# Imperial Valley College

## Americans with Disabilities Act Facilities Evaluation

# Americans with Disabilities Act Facilities Evaluation

SHEET 1

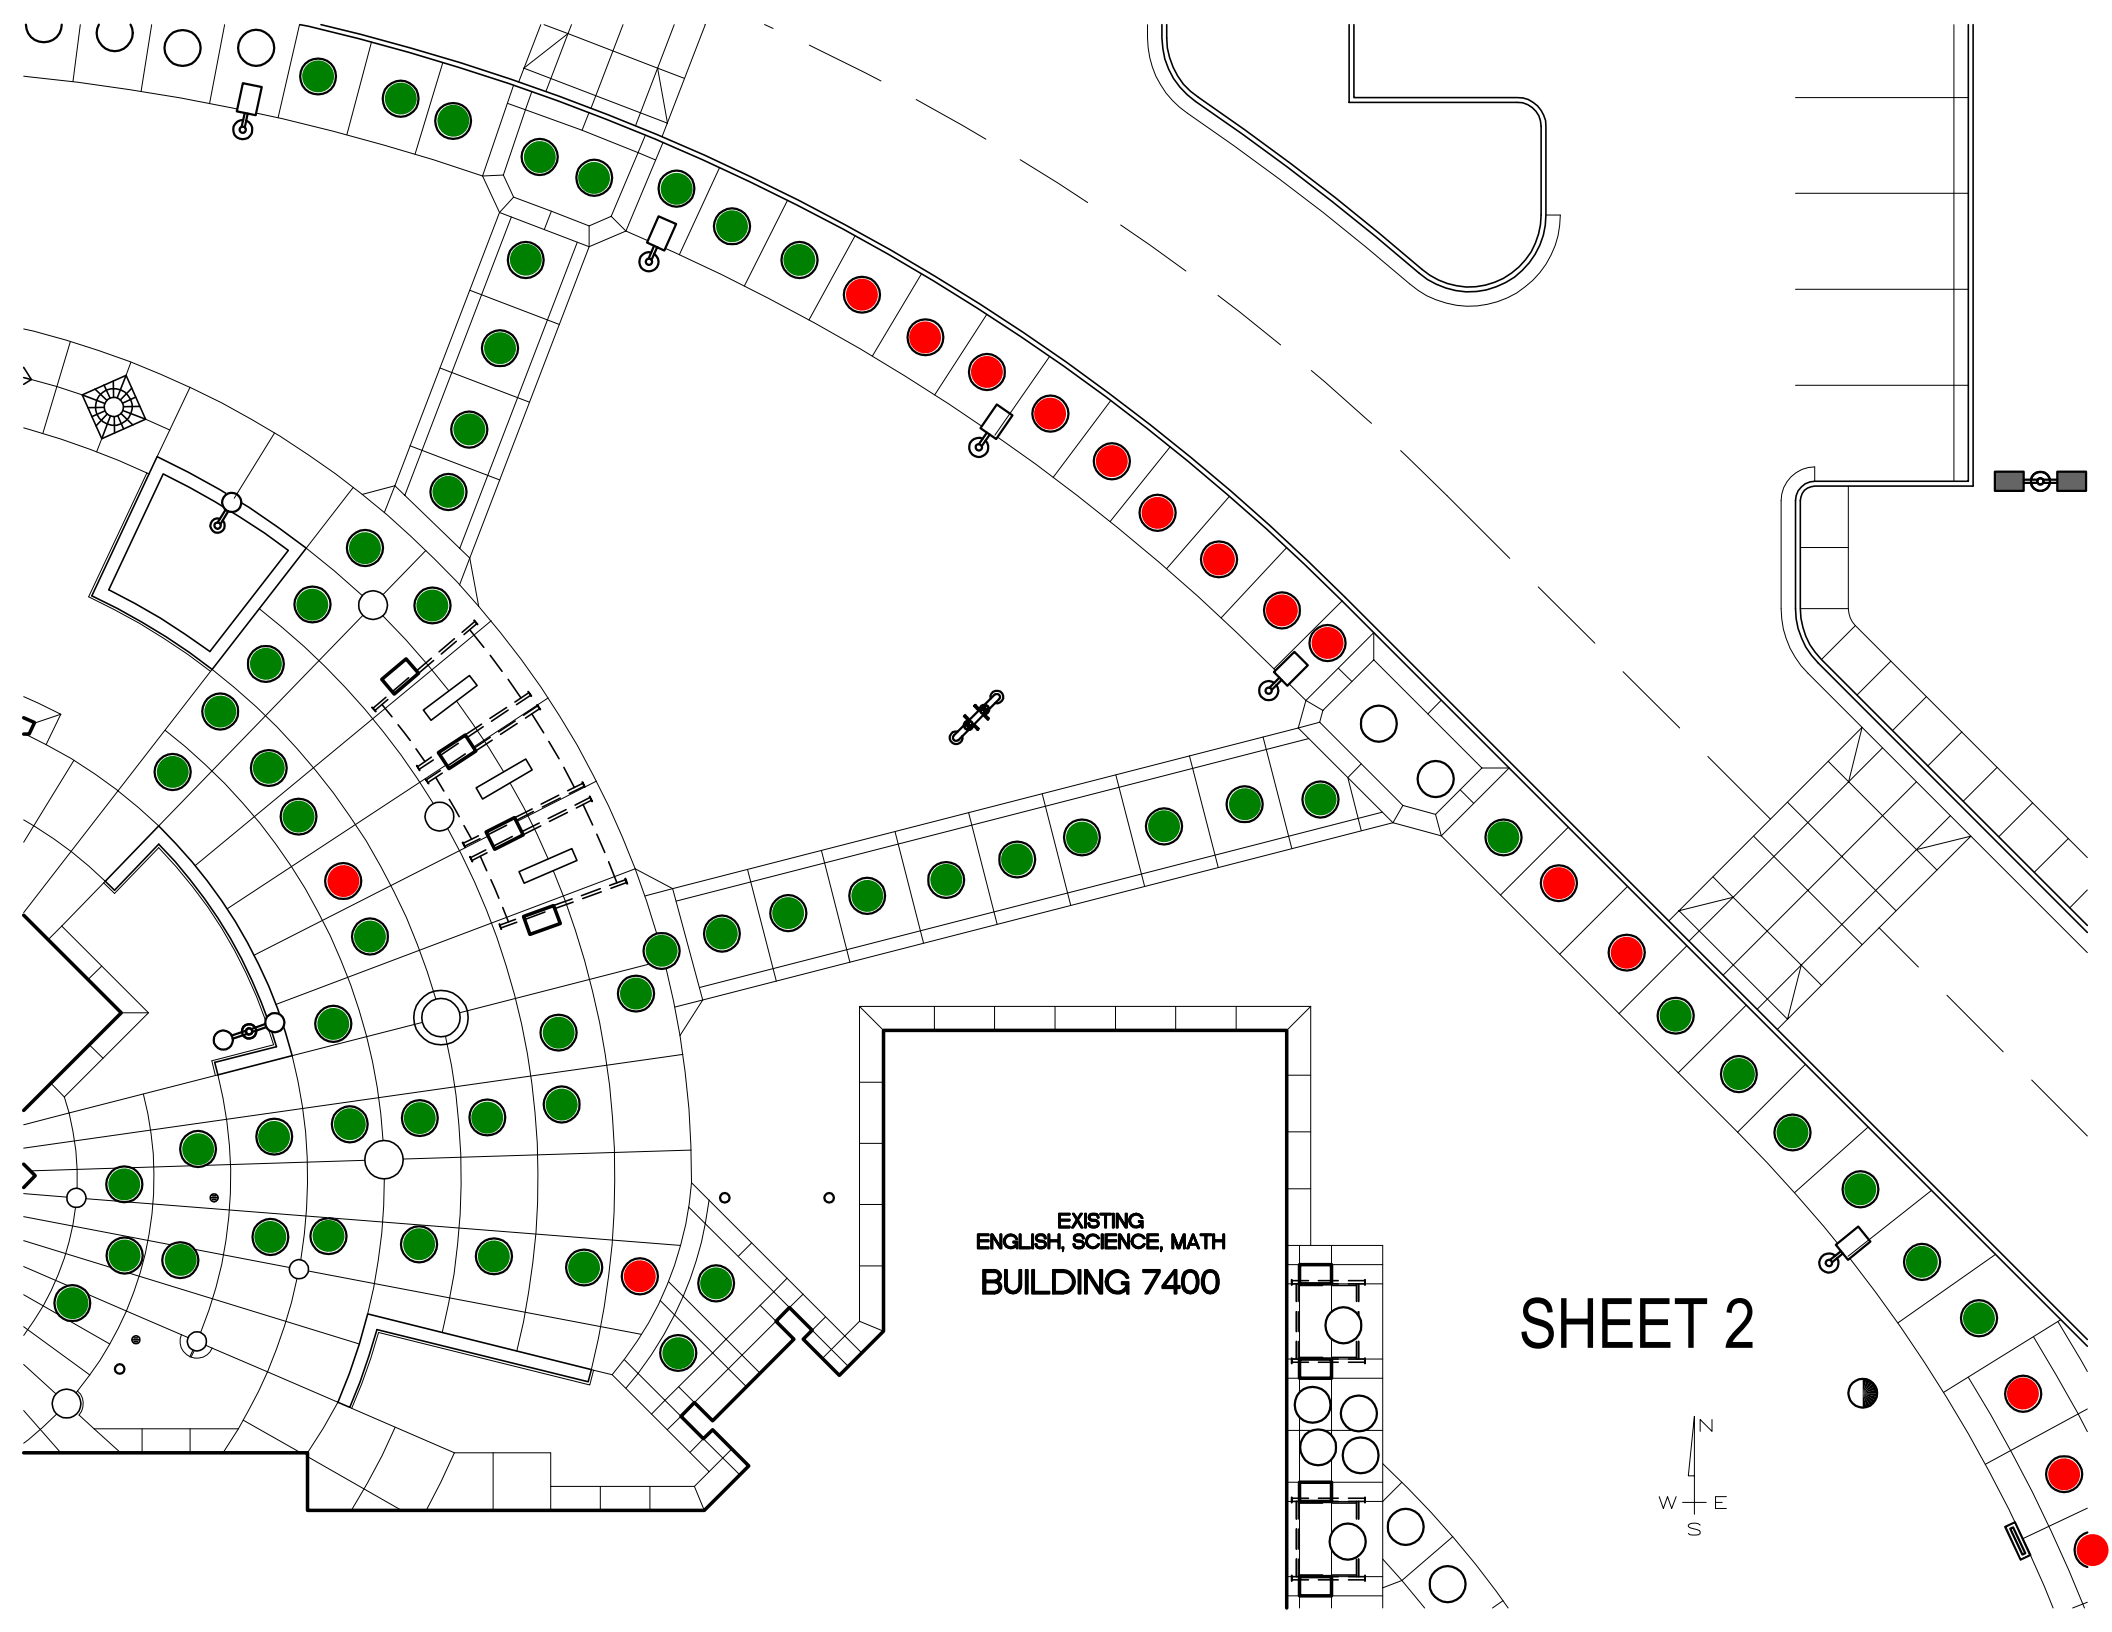
- Sheet 1: A couple of expansion joints in the concrete have formed gaps in between sidewalk sections.
- Sheet 2: Significant portions of the sidewalk show large cracks along or originating from expansion joints, occasional gaps in between concrete slabs, and generally bad slopes.
- Sheet 3: Minor cracks and large gaps in expansion joints, a couple of slight changes in level from one concrete slab to the next along the sidewalk, some bad slopes.

SHEET 4

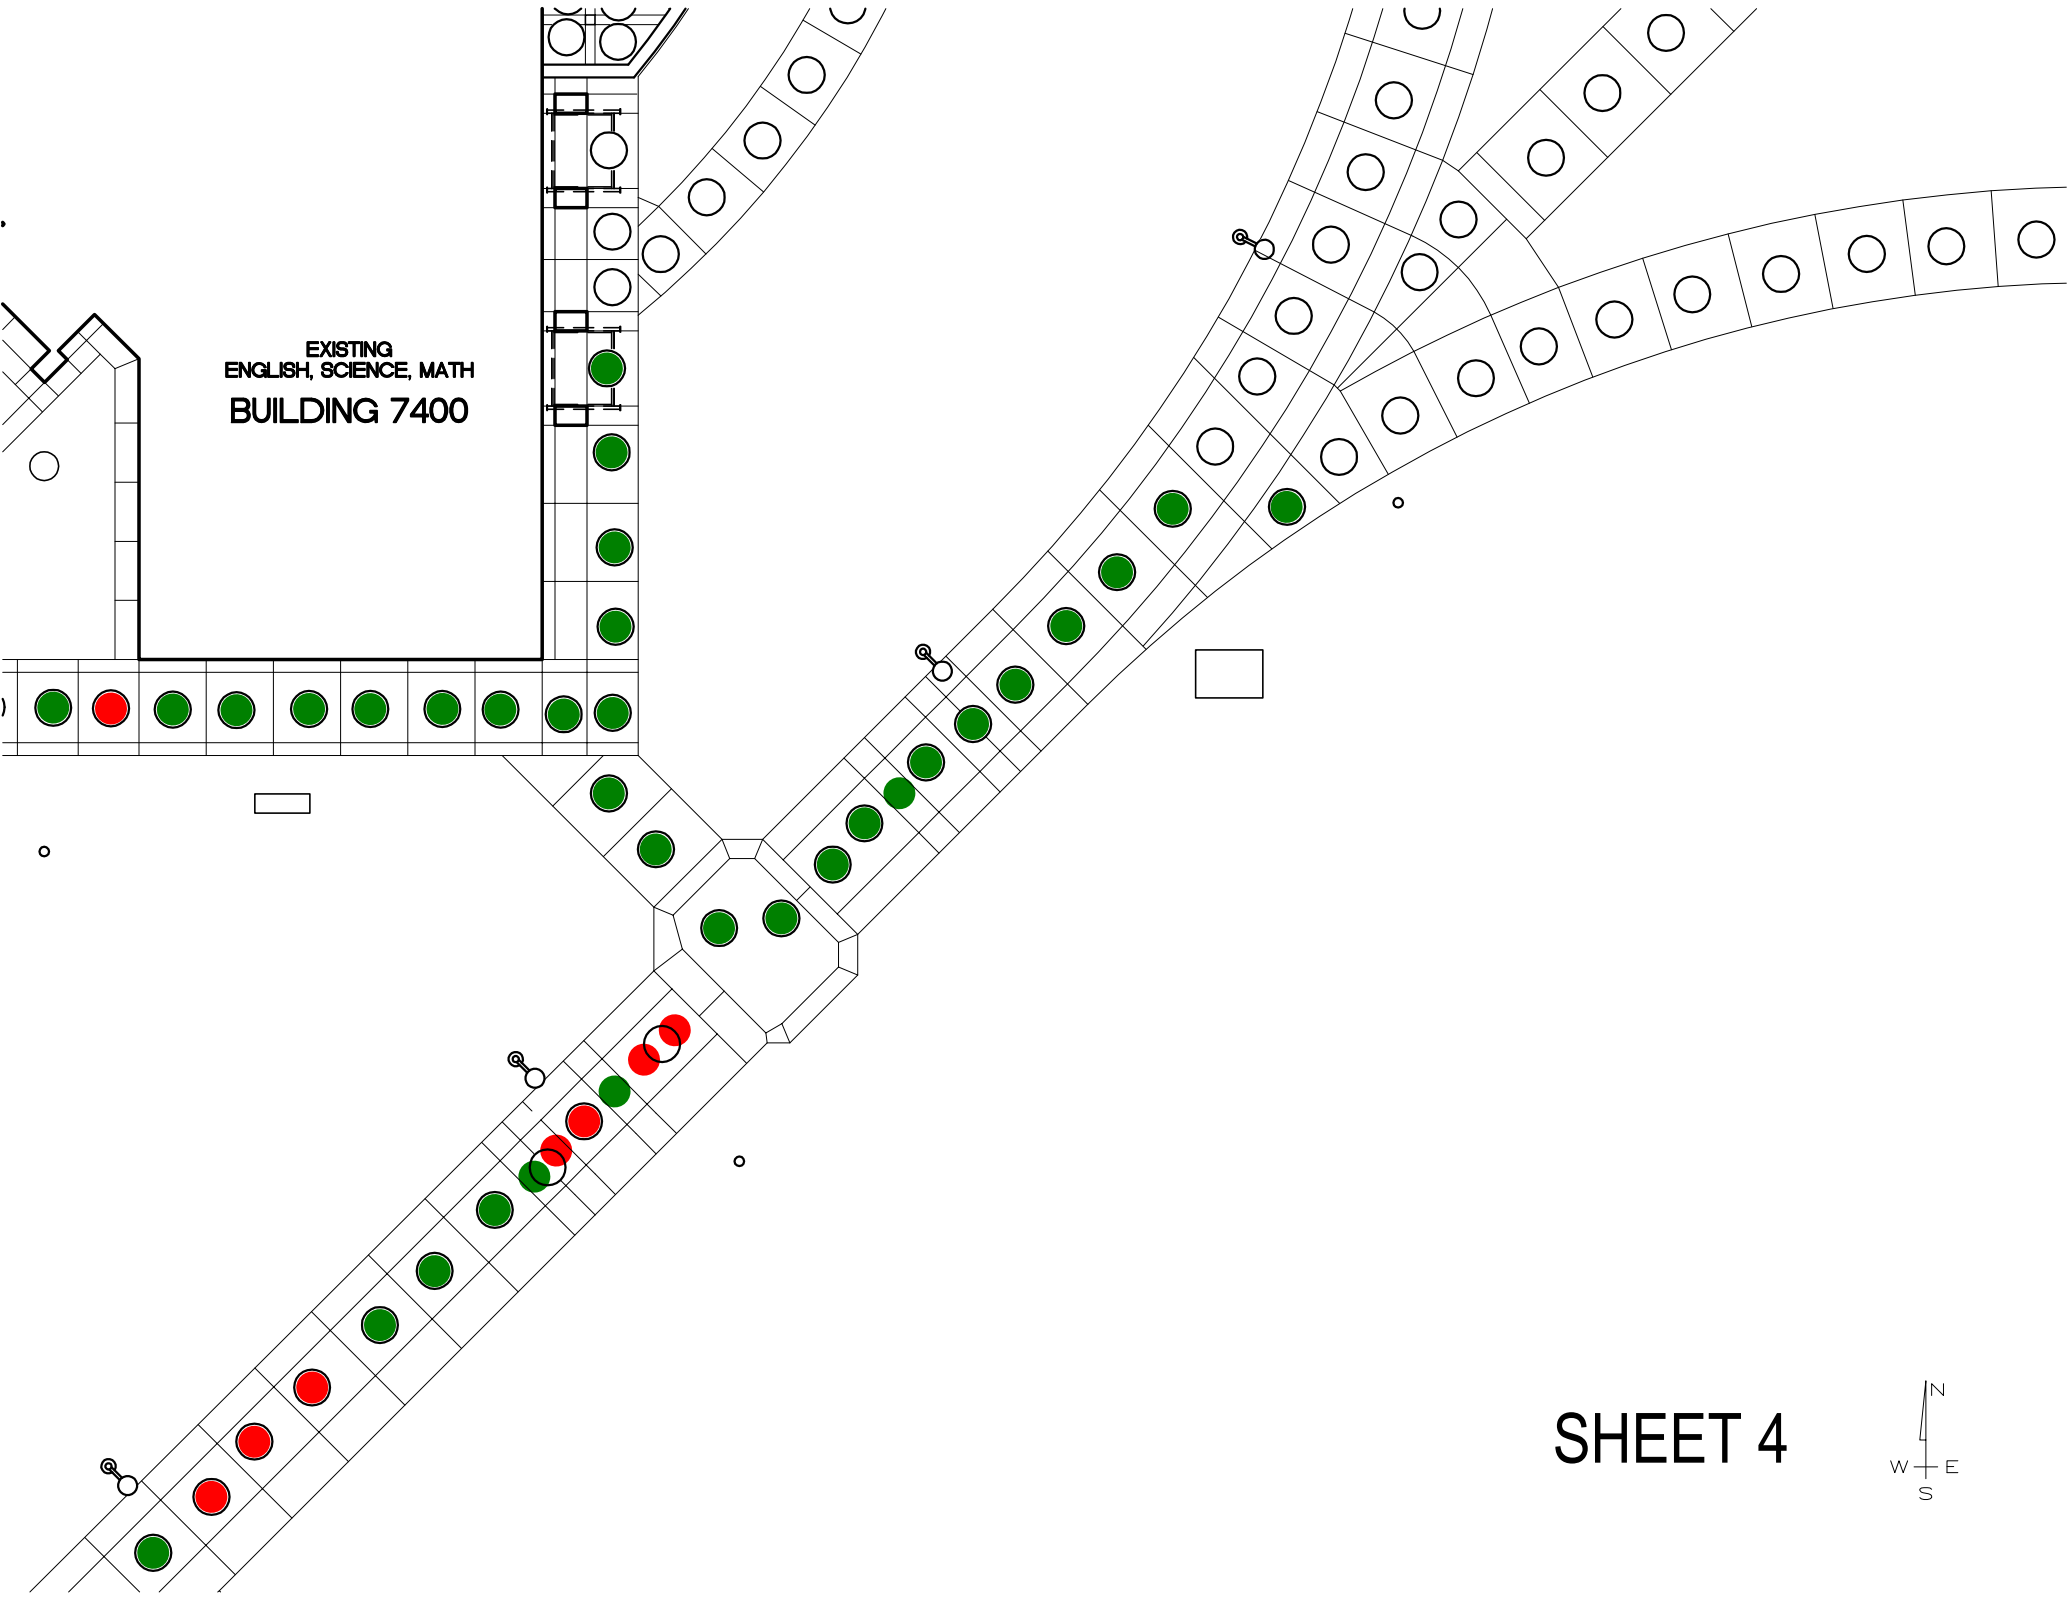
- 
- Ramp (East of Building 7400): Compliant.
  - Handrails of Ramp: Compliant.
  - Sheet 4: Minor cracks across concrete slabs on the sidewalk, some significantly large gaps in expansion joints, a couple of bad slopes.

SHEET 5

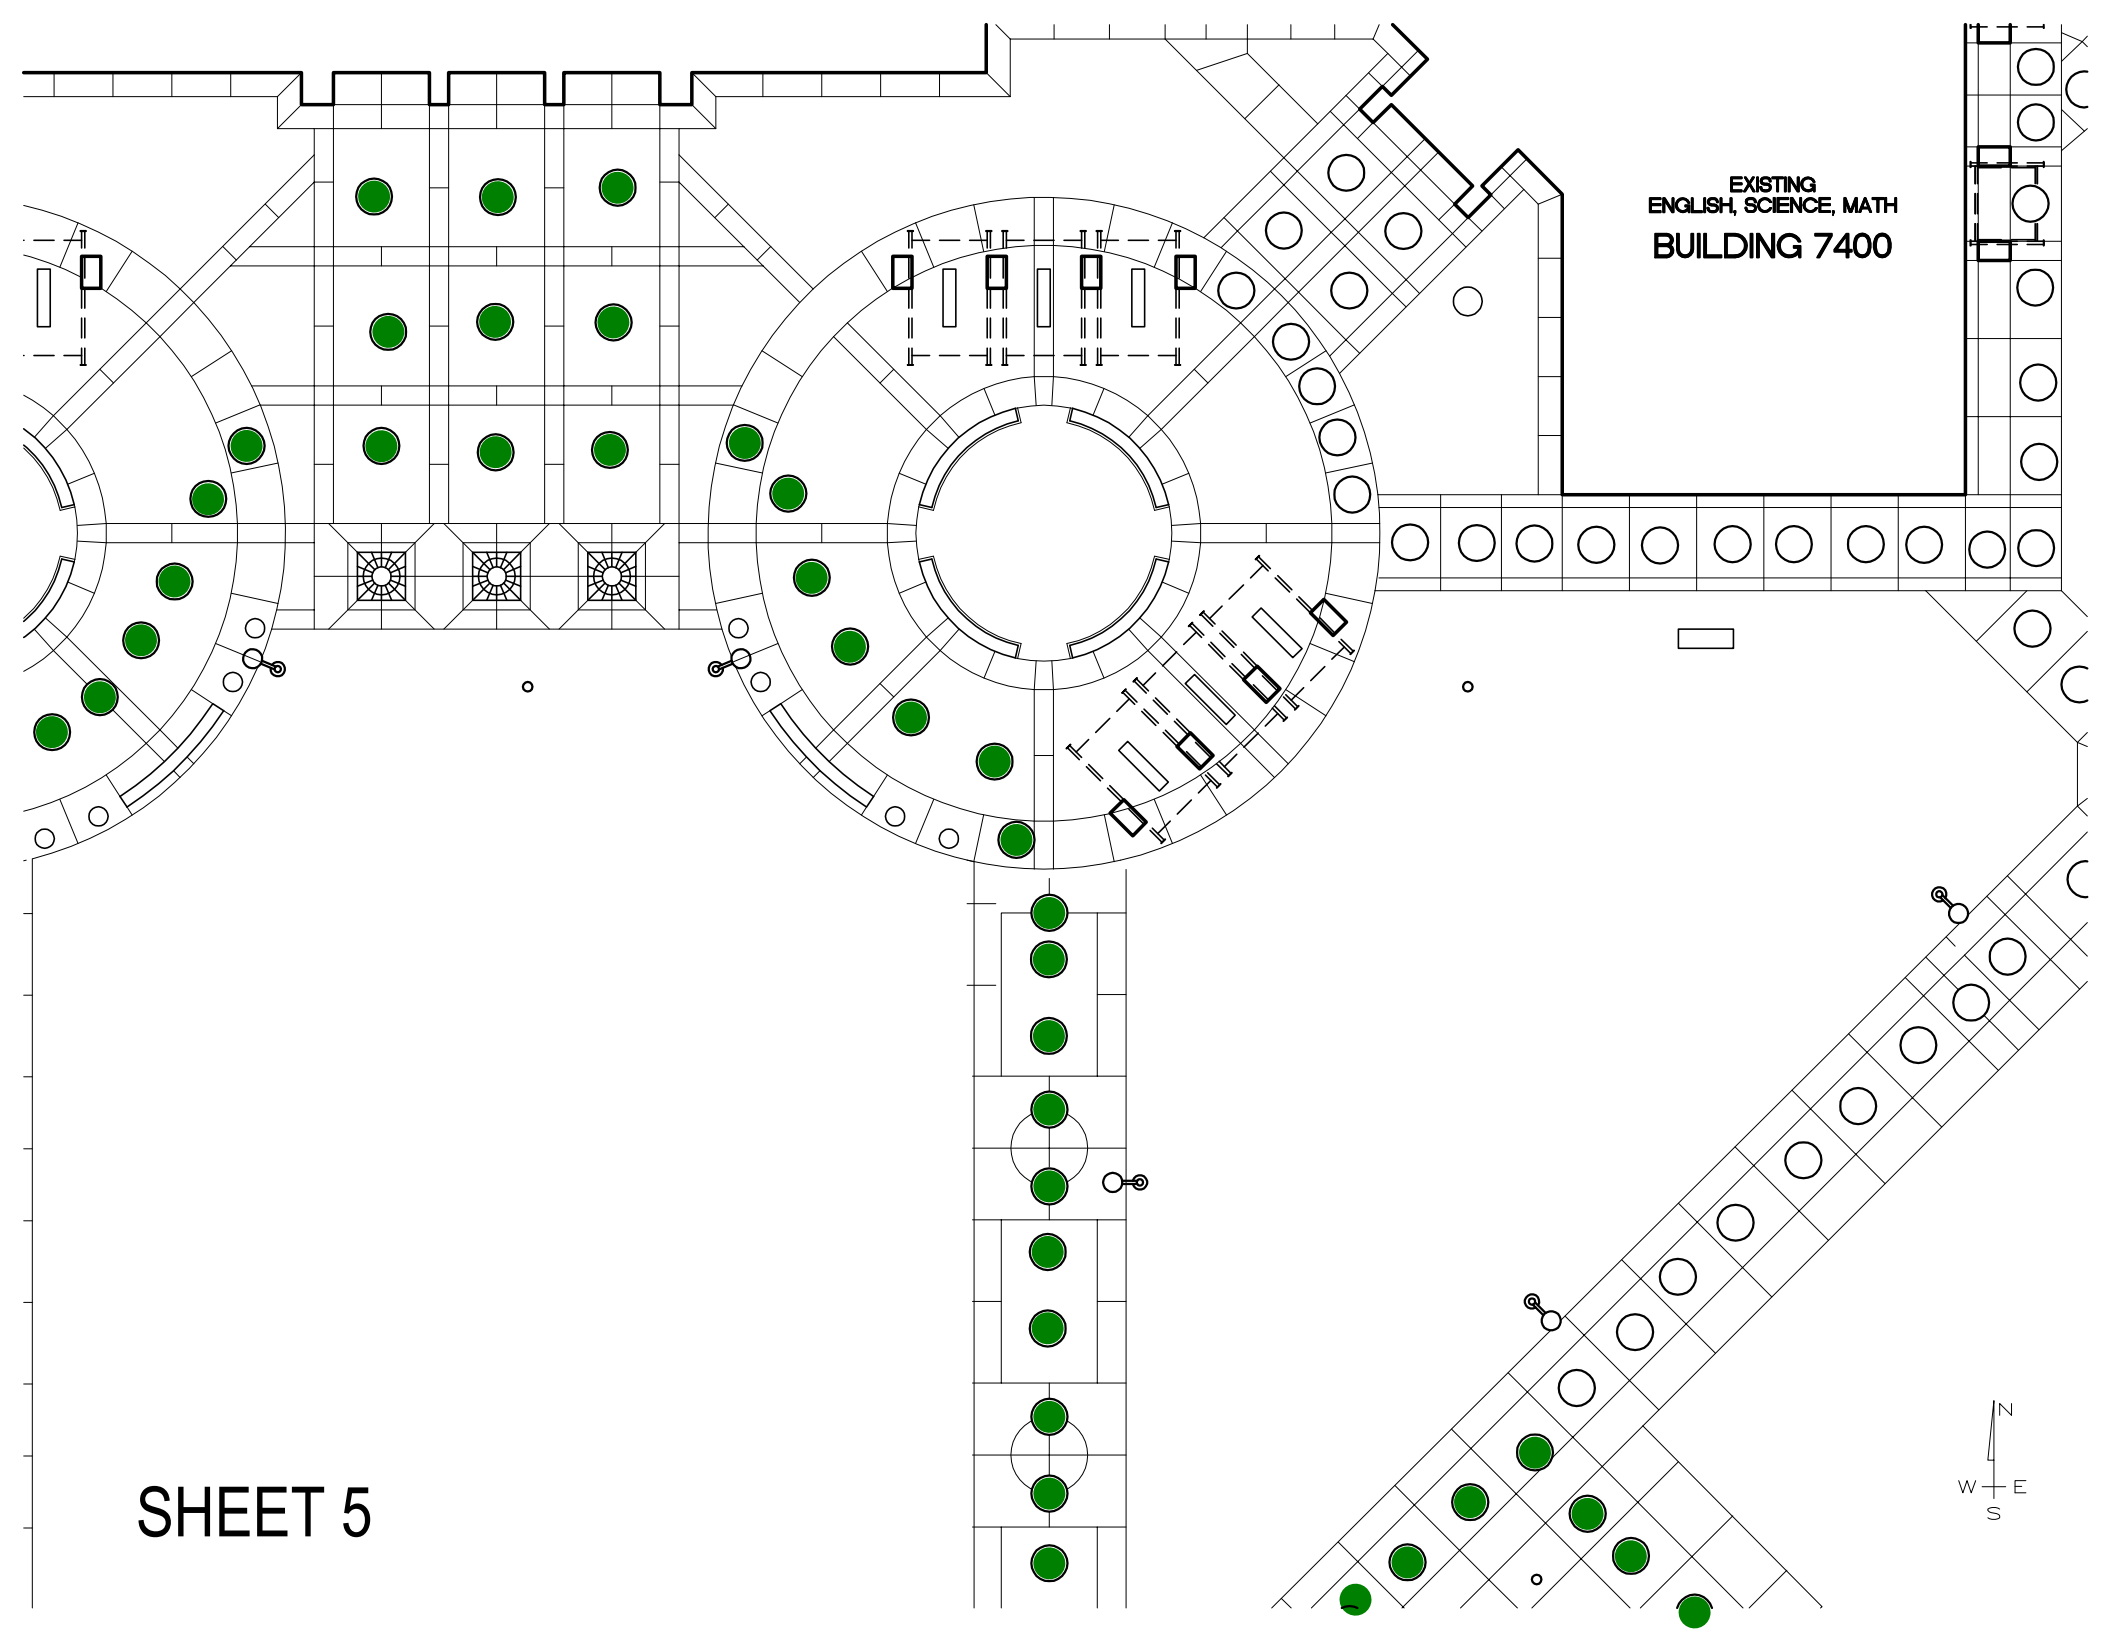
- Sheet 5: A couple of gaps between concrete slabs, minor cracks.
  - Sheet 6: Some large gaps and minor cracking in expansion joints, some sections of sidewalk with bad slope, multiple cracked small concrete slabs.
